List of Commenters

SUBJECT: Bicycle Master Plan – MCDOT Public Hearing Comments

Figure 4. East County Bike Plan Neighborhood Bikeway Suggestions

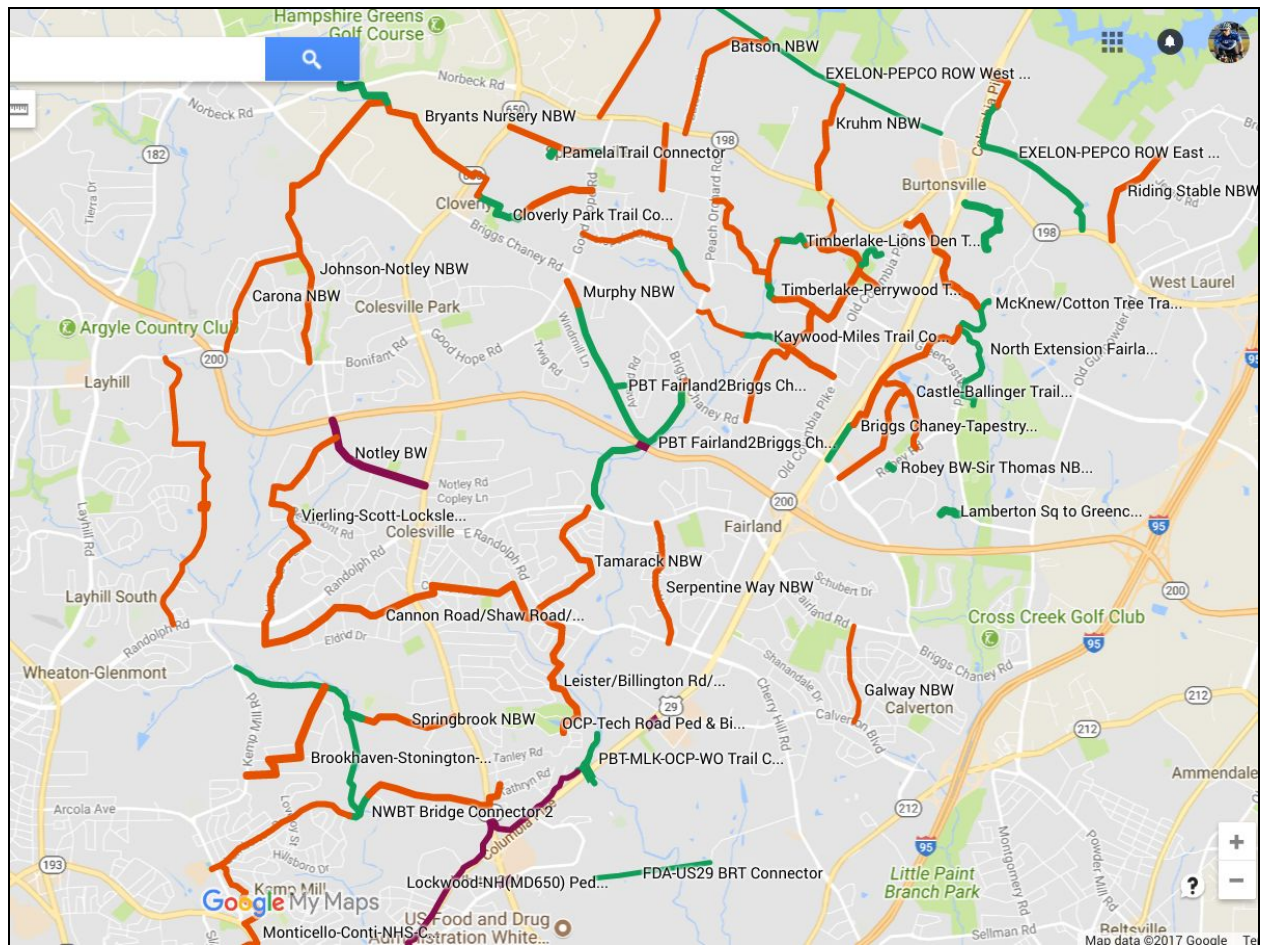
Figures 4. and 5. provide thumbnails of detailed graphical depictions of our recommended bicycle infrastructure to be included in the Montgomery County Bicycle Master Plan. We encourage your team to review the detailed recommendations that we have catalogued in the following media:

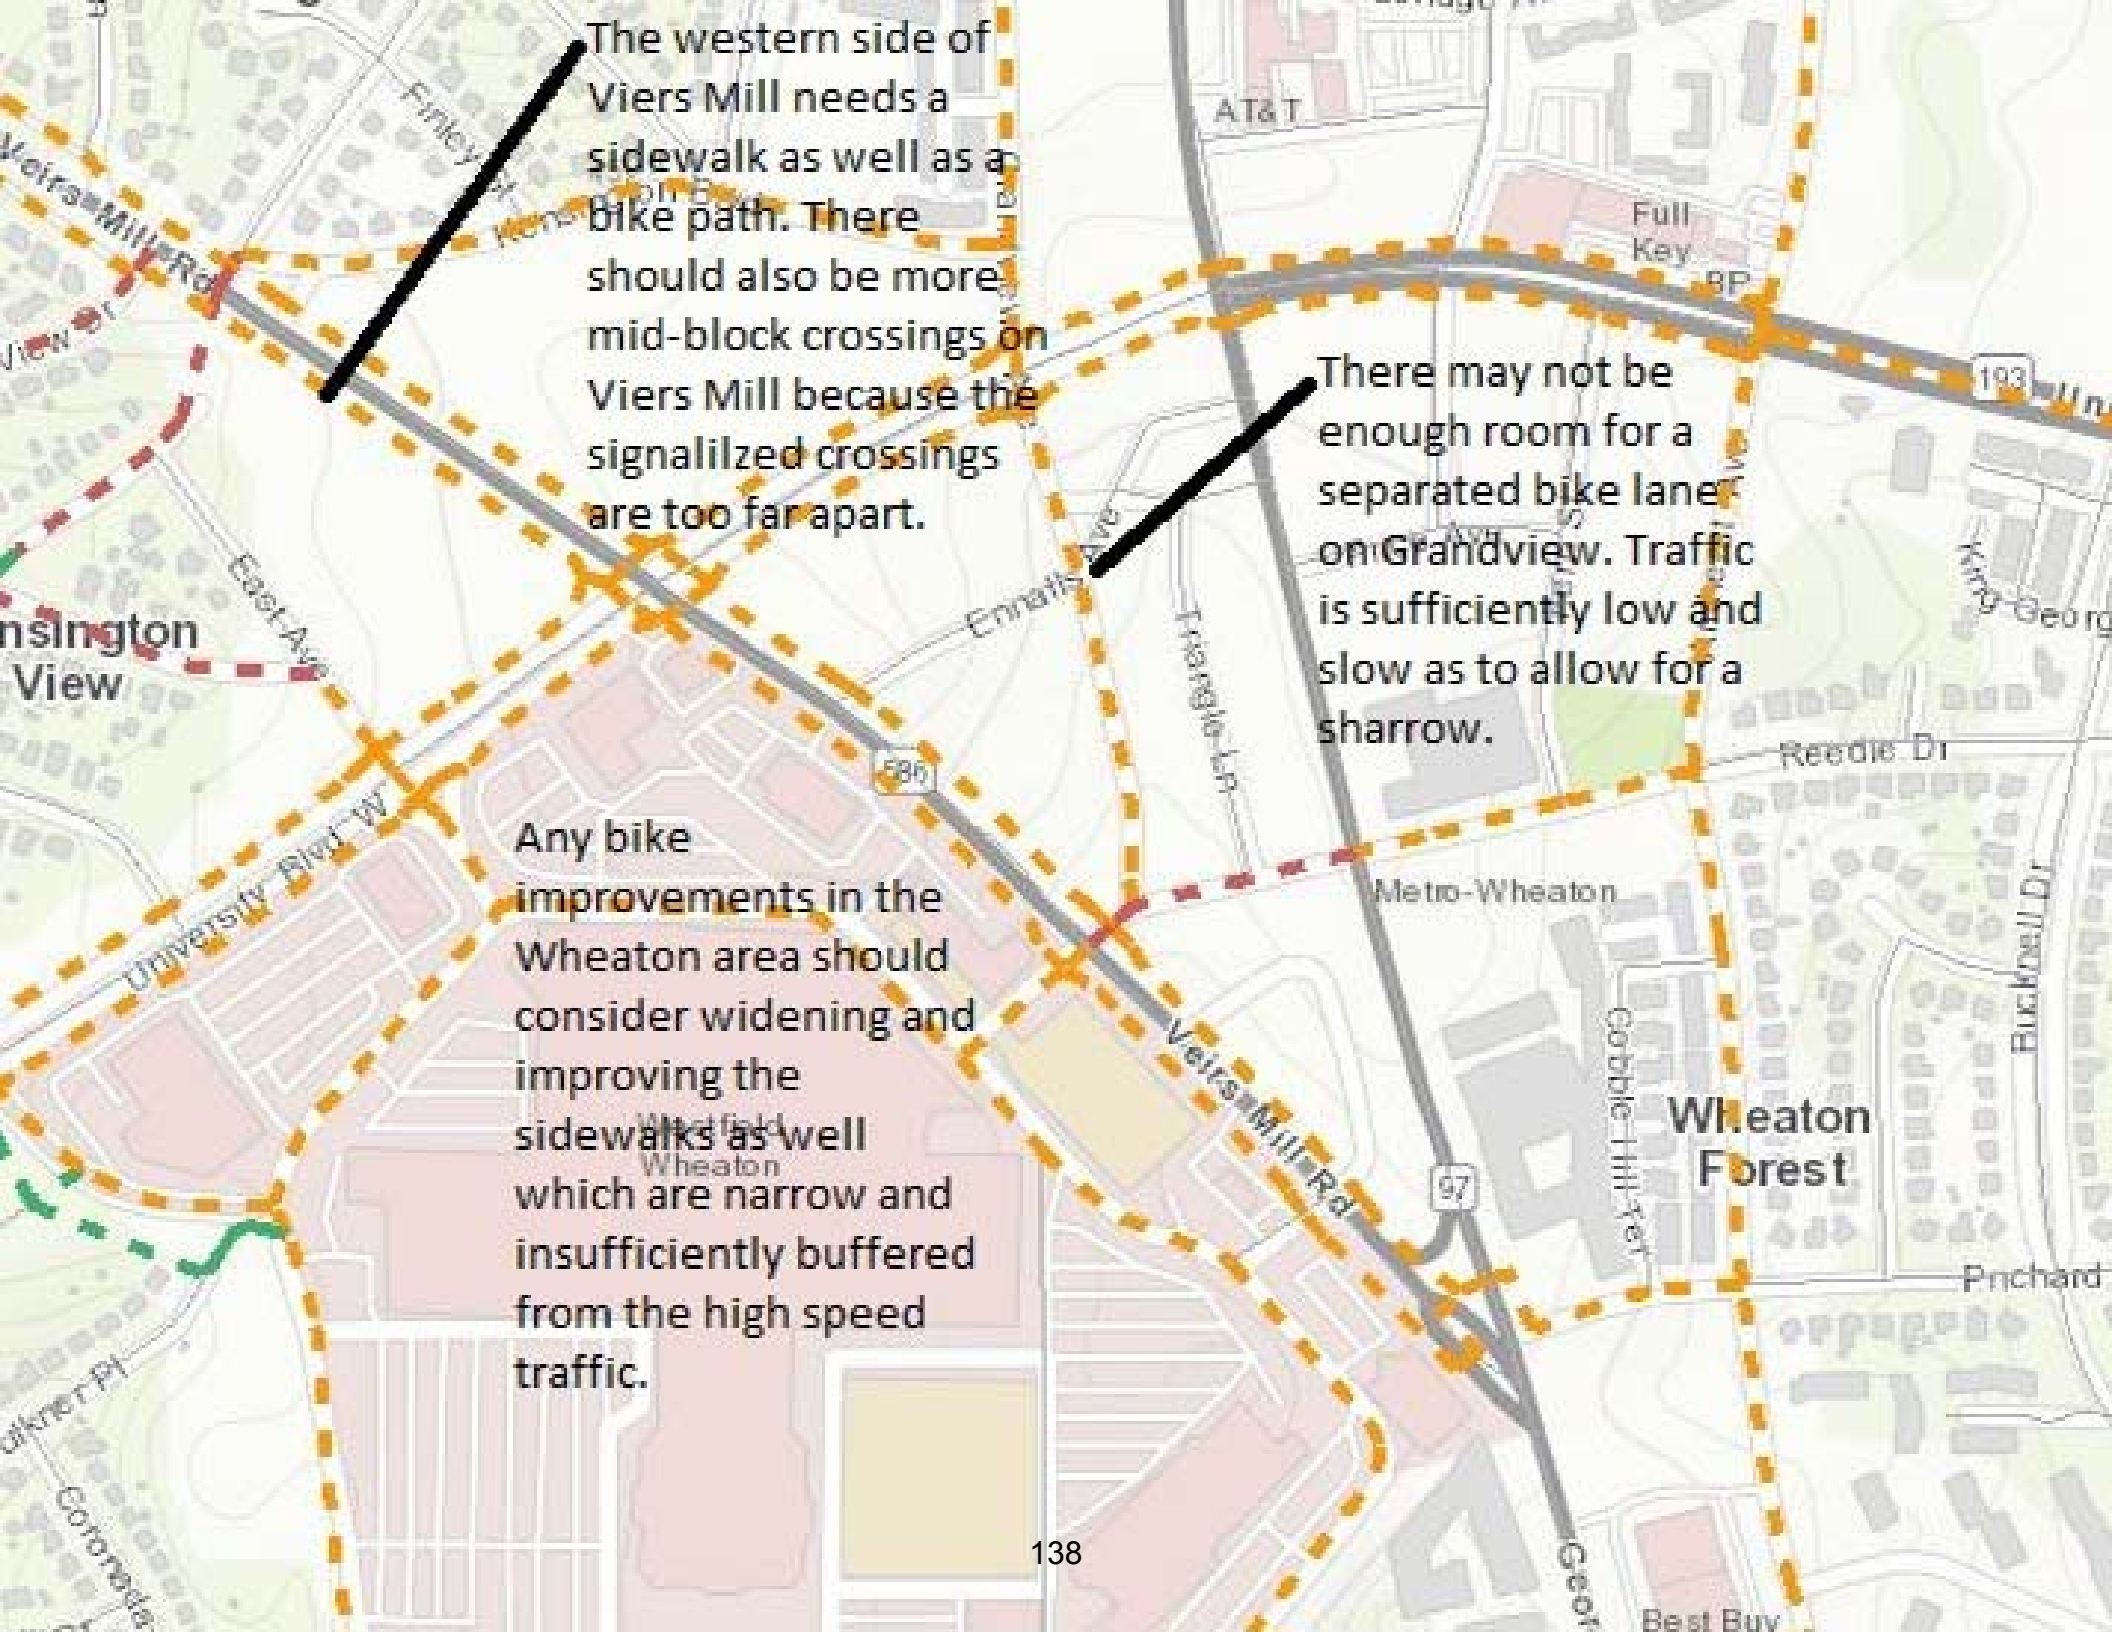
Add a new bike path connection from the terminus of Kenton Drive to the parking lot at the end of Upton Drive.

Connect this new path to the existing path along the existing park fence.

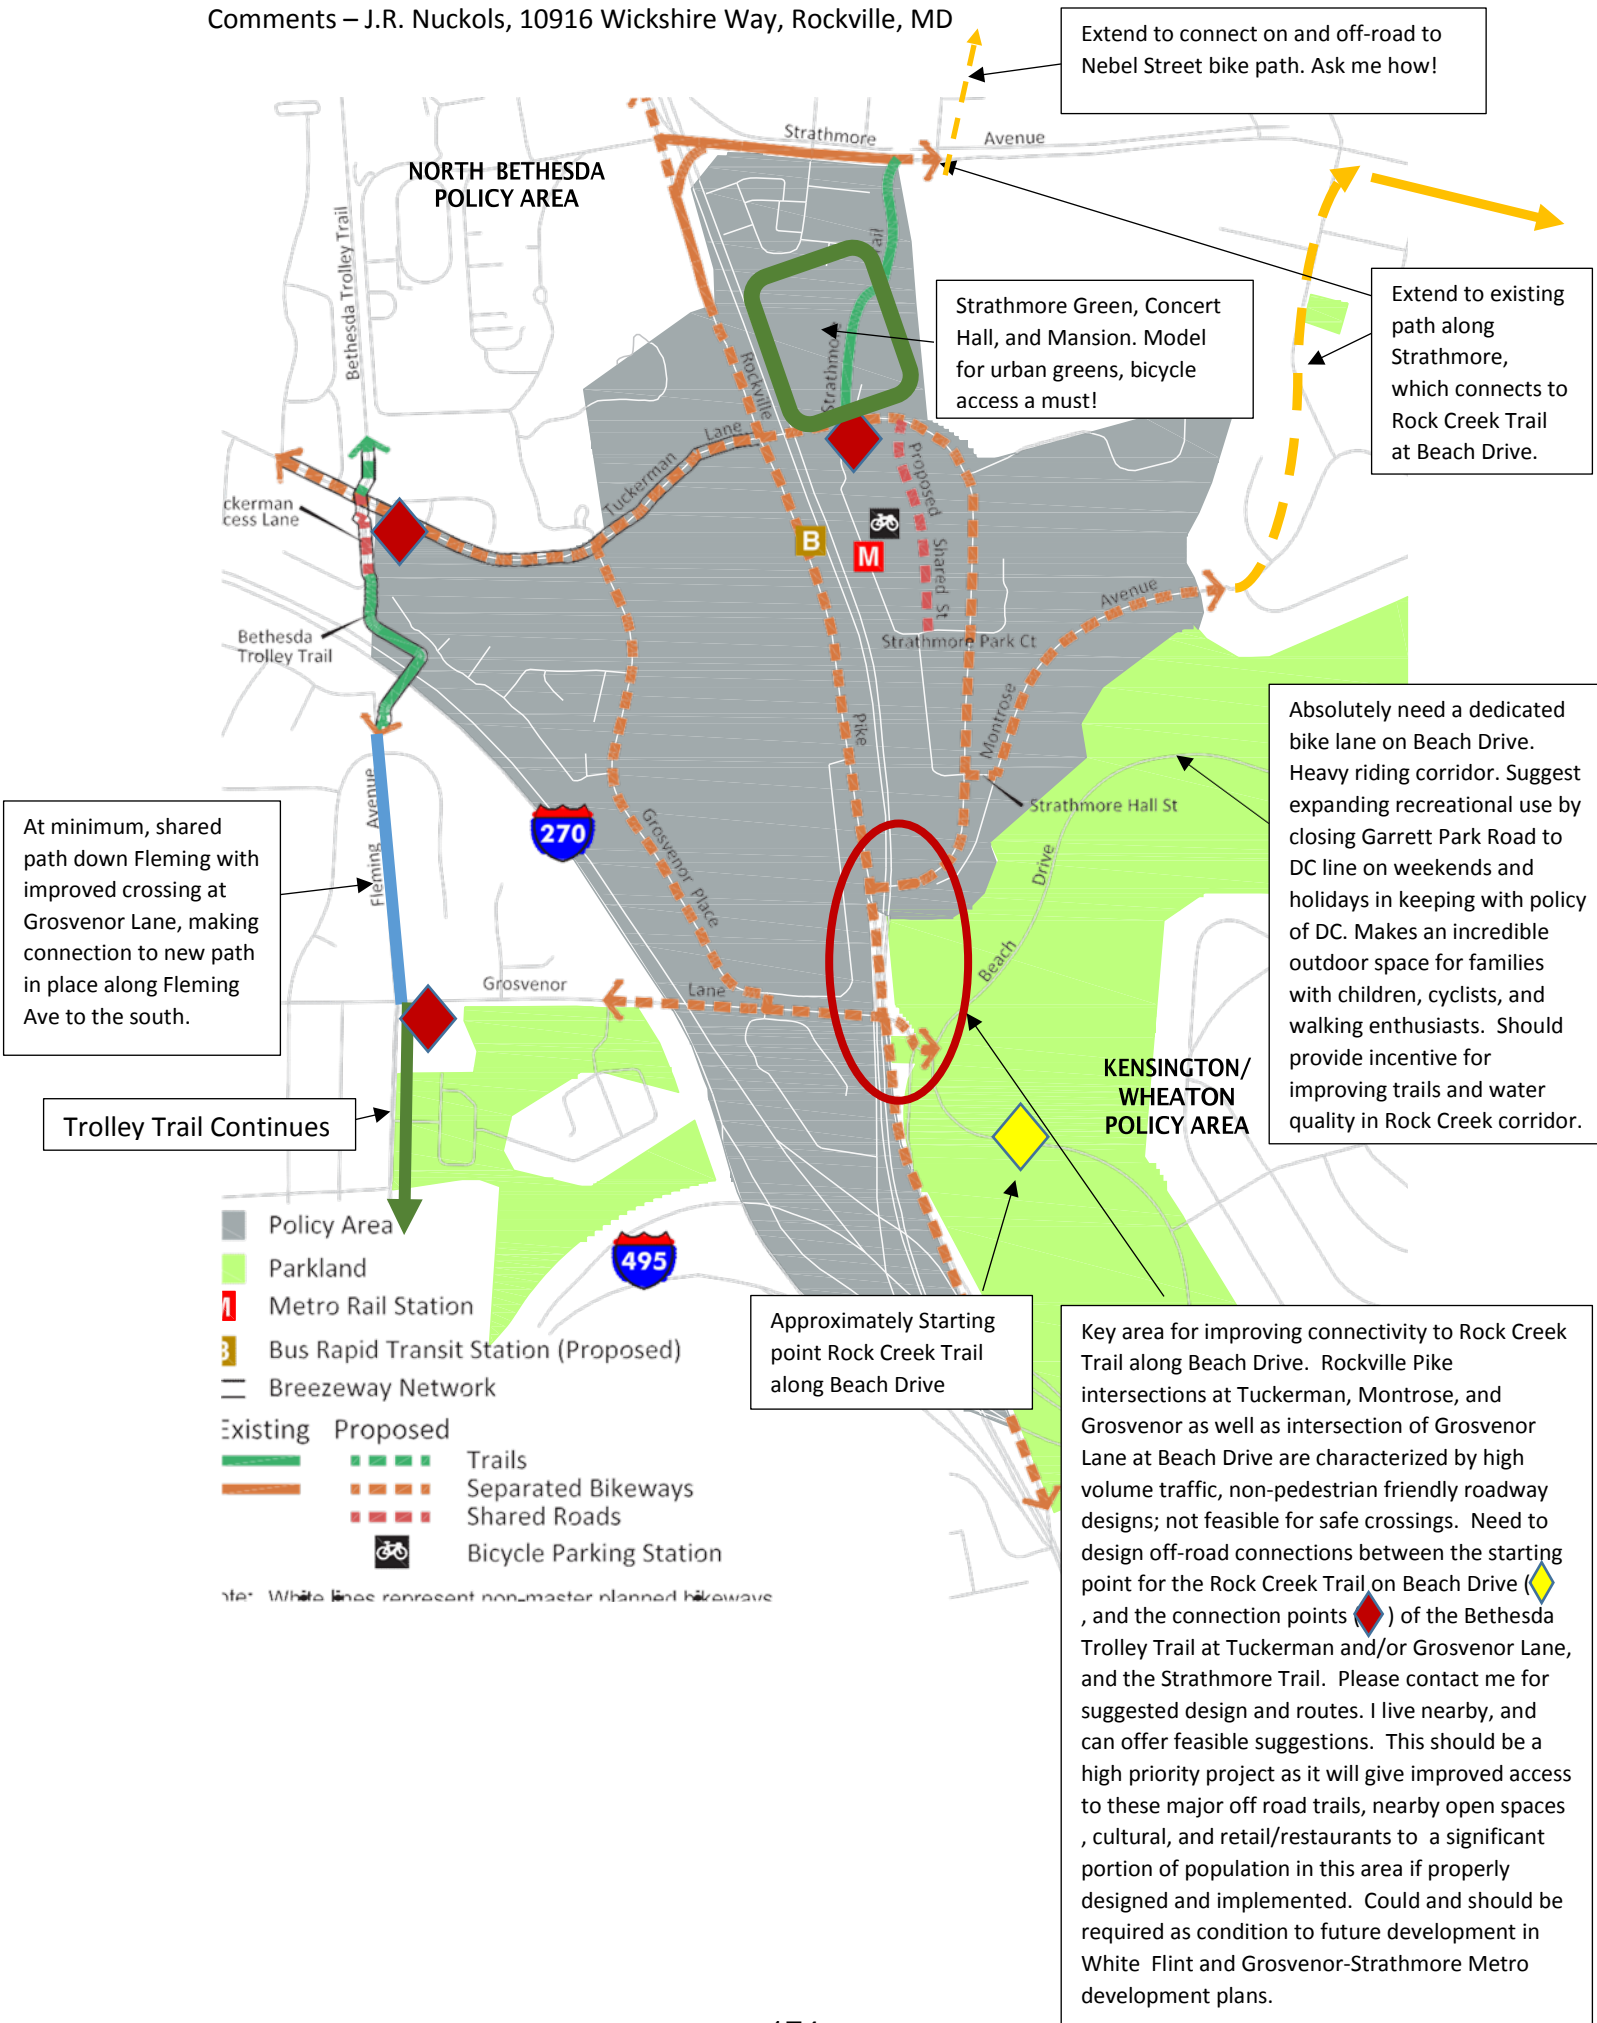
Attached please find my specific recommendations for improving the plan towards the above goals in the Grosvenor Planning Area (P. 290) in the report.
